Caloundra Administration Building Repurposing Project

Q1939 STAGE 3 - Due Diligence Report

DATE 25th February 2021

**BUILDING CERTIFICATION REV A
 STAGE 2A - PRELIMINARY DESIGN REPORT
 PROPOSED CHANGE OF CLASSIFICATION AND MAJOR REFURBISHMENT**

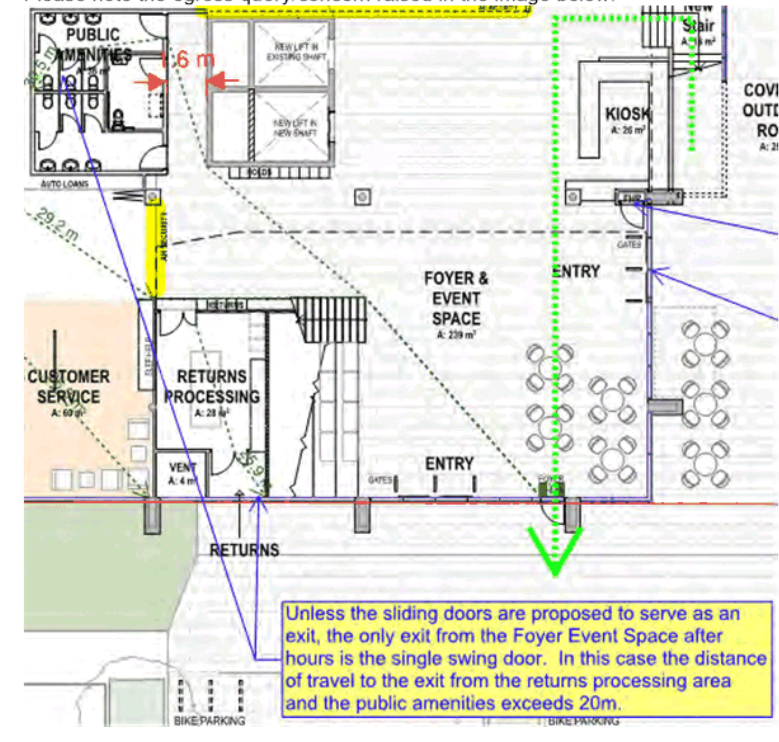
Please clarify if the basement swing doors depicted in the image below exist as exits in both directions.

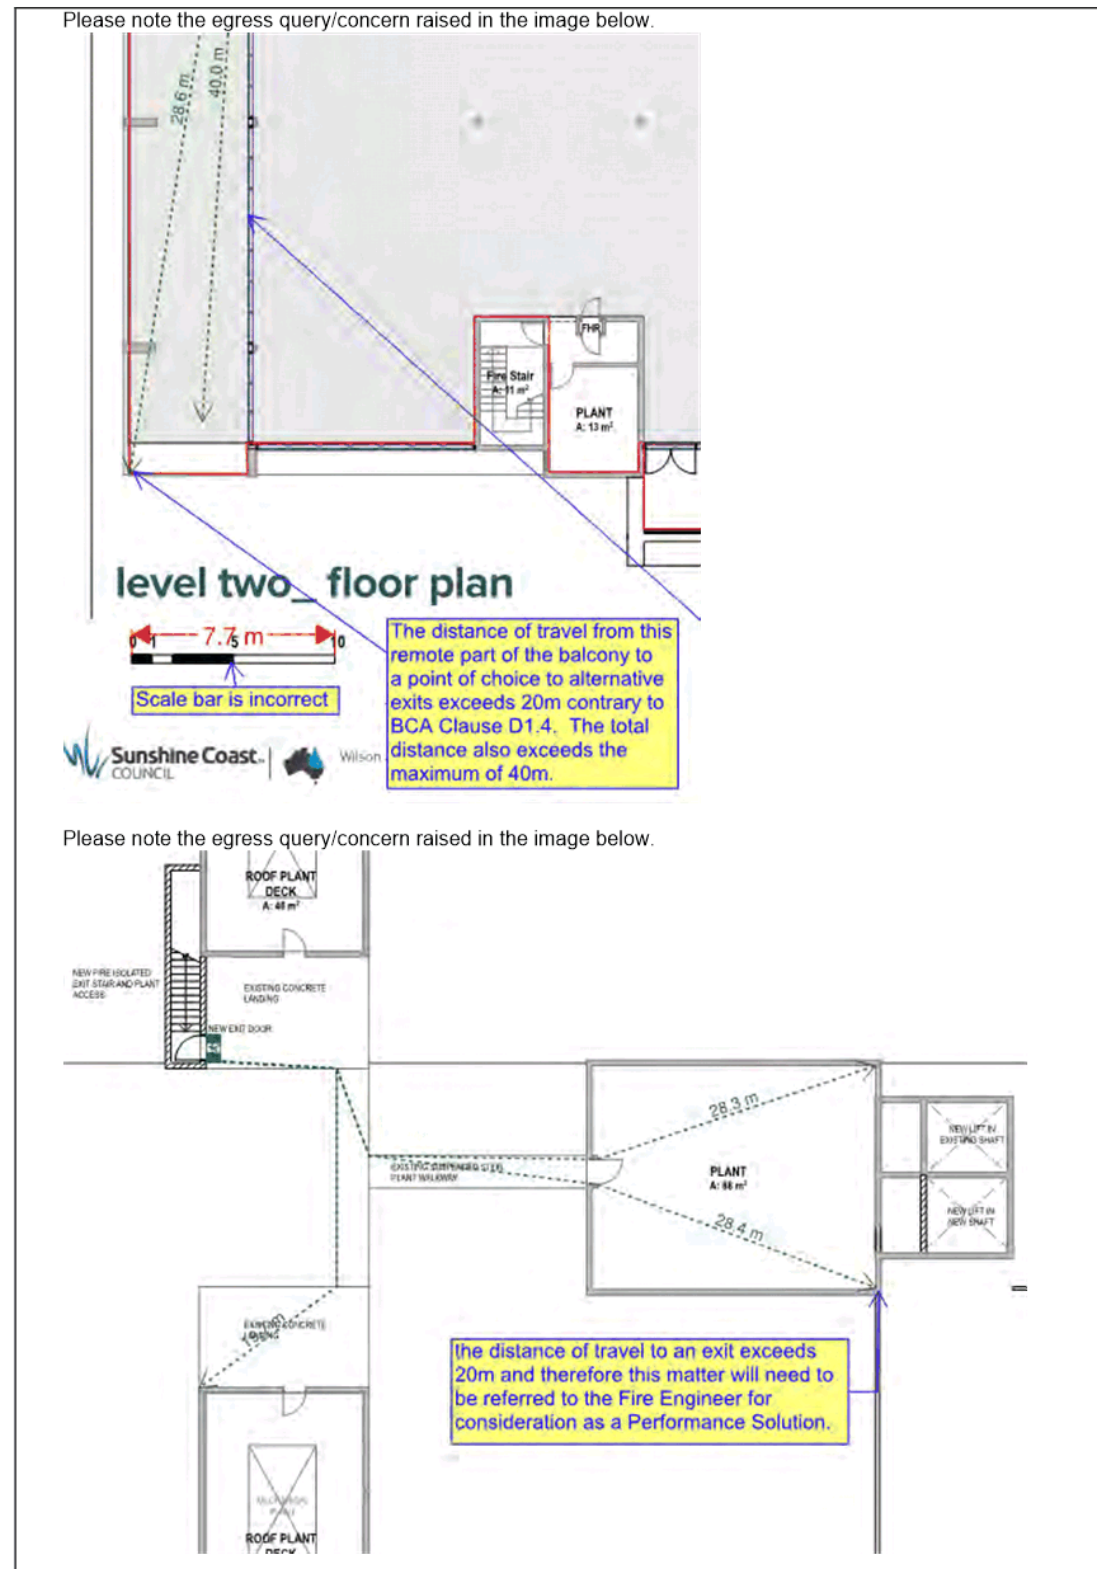
Please note the egress query/concern raised in the image below.

Unless the sliding doors are proposed to serve as an exit, the only exit from the Foyer Event Space after hours is the single swing door. In this case the distance of travel to the exit from the returns processing area and the public amenities exceeds 20m.

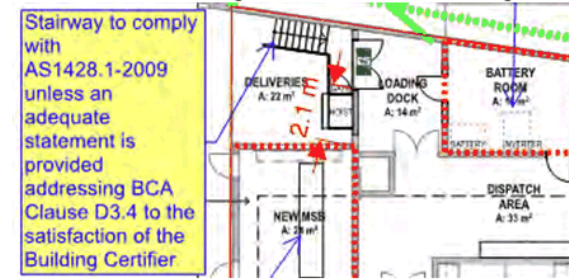
Please note the following comment on the basement image below.

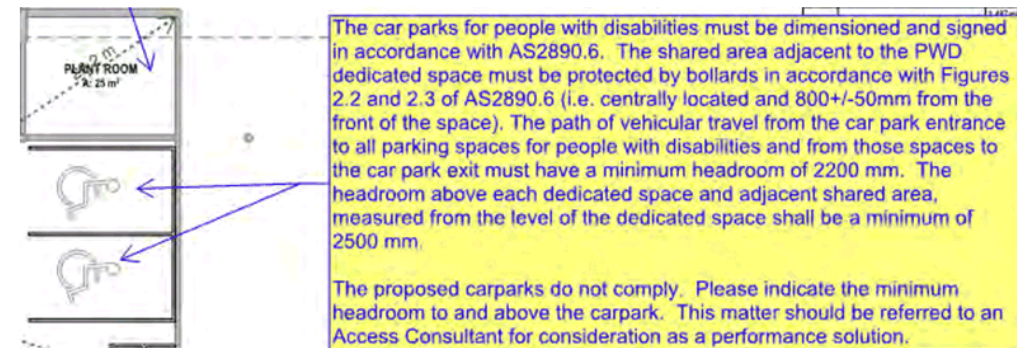
Please note the following comment on the level 1 image below.

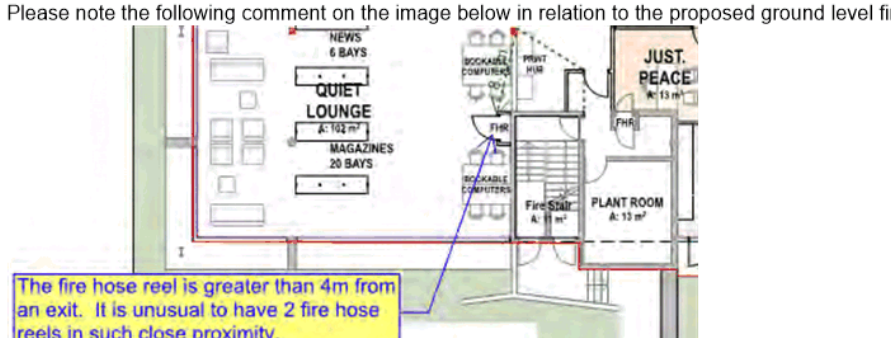
Please note the following comment on the image below in relation to the existing basement fire reel.

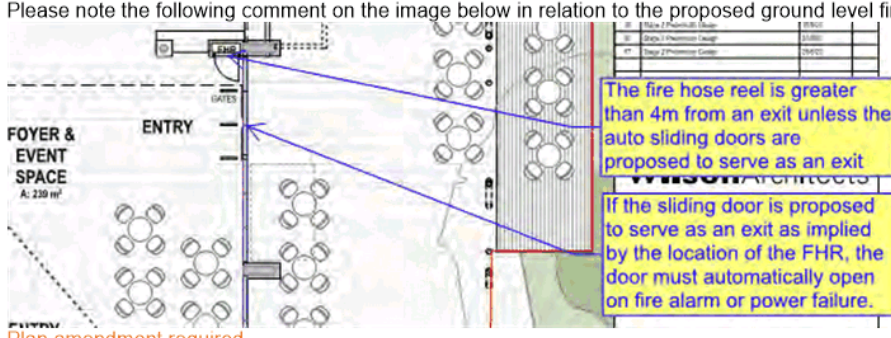
Please note the following comment on the image below in relation to the proposed ground level fire reel.
